Product Change Notification

Changes to HPH pin carrier

29th June 2026

Appendix A – Details of design change

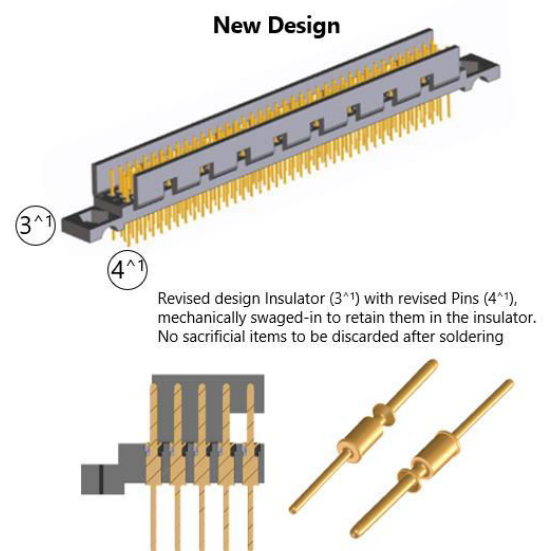
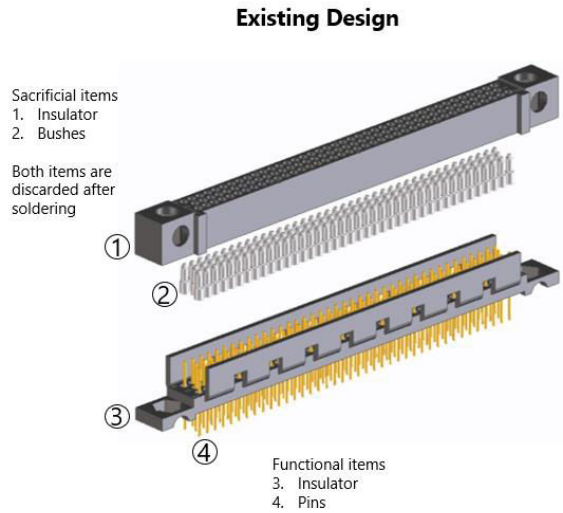
The current design uses sacrificial components with PTFE bushes to hold the pins during the soldering process; these items are subsequently discarded after soldering process. Other than the fact that the part is a waste, PTFE is identified as 'forever chemical' and several manufacturers have indicated plans to stop production in coming years. The design change done to the insulator together with the pins will ensure the pins are mechanically swaged directly into the insulator. This means the pins are retained inside the insulator before and during soldering process without the need for separate sacrificial bushes or a temporary insulator. Please refer to Appendix A, which outlines the details of this change.
